Norwell Solar Farm Steering Group

Road Solar and Biodiversity Park (GNR Project)– project ref. EN010162

Deadline 3. Written Summary of Oral Submissions ISH/3

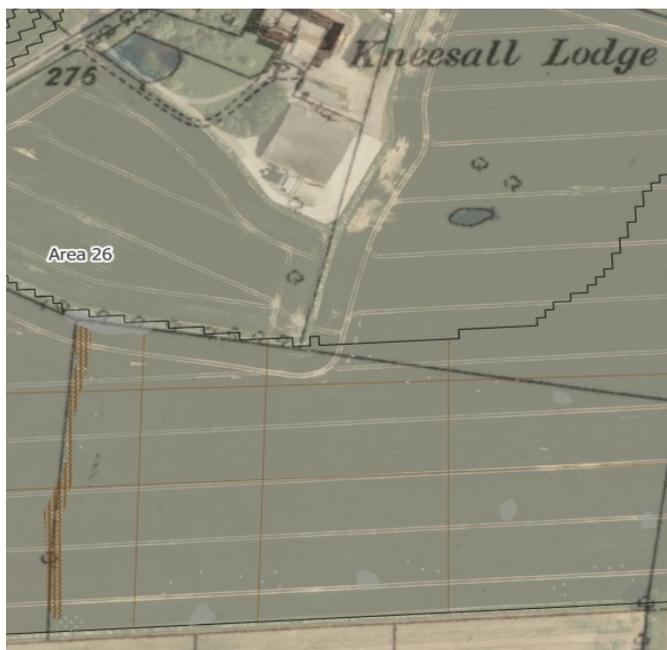
- 2.2 The map pin is coloured blue signifying that it has a Habitat Suitability Index rating as Excellent for GCN, though on the day of the survey of the pond, it tested negative for GCN DNA.
- 2.3 In terms of how this location is to be affected by the development, the below graphic is taken from the Applicant's Masterplan, demonstrating its proximity to planned panelling.

- 2.4 The location of the pond is shown as a faint light blue circle. It is the proposed development on field W7 above that is a cause for concern. The pond is pictured below:

- 2.8 The concern is that the panel mounting structures in field W7 will be pile driven into the ground, below which is this pipe. Being as this field is one of the highest and most exposed in the development, the panels here will have to be anchored deeply.

- 2.9 The northern boundary of field W7 will have deer fence posts anchored in concrete buried in the ground. The clear concern here is that either of the above two ground penetrations could inadvertently fracture this pipe and cease the feed to the pond, leading to a long term deterioration in that feature, with an associated adverse impact on this wildlife habitat.

- 2.10 It is requested that the Applicant takes further measures to confirm the exact location of the pipe and to ensure that all pile driving and excavation takes place around it, not into it. There should also be a

requirement that if it is shown that the pipe has been fractured and the feed to the pond lost, then the Applicant should make an undertaking to repair the damage and restore the spring feed at the earliest opportunity.

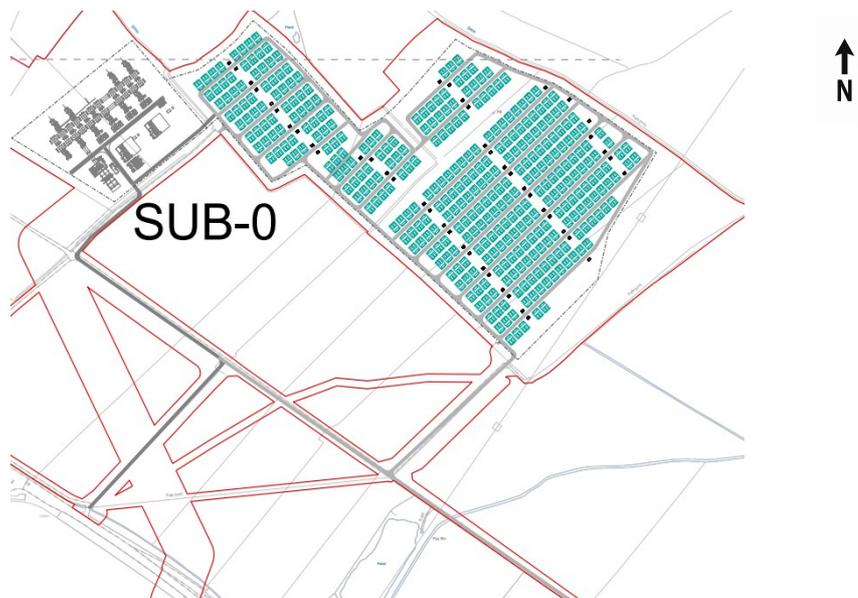
- 5.2 It is clear that revised plans must show the location of any holding pond. More importantly, it will hopefully demonstrate the access plans for tankers which are often articulated HGVs. At the moment, the only tarmac access to the site is in the west.

- 5.3 Ordnance Survey maps tend to suggest that the main part of the BESS area is quite flat with a gentle rise in the area of the substation and towards the wood to the north. If the incident is still live, tanker drivers would very much be at the mercy of the winds. Given the potential toxicity of smoke, it seems unlikely that NFRS would be comfortable with anyone entering a site of this design whilst the fire is still going.

- 5.5 Perhaps more importantly, there is a need at this stage for the Applicant to explain how contaminated fire-water from, for example, the most northern battery area in the above plan will make its way to any pond, as opposed to soak into the ground and eventually the water table. There is mention of pumping but how and by whom is not

clear. It seems unlikely that NFRS will allow personnel onto site whilst the fire is in progress and equally unlikely that NFRS will allow their own pumps to move the corrosive contaminated water around.
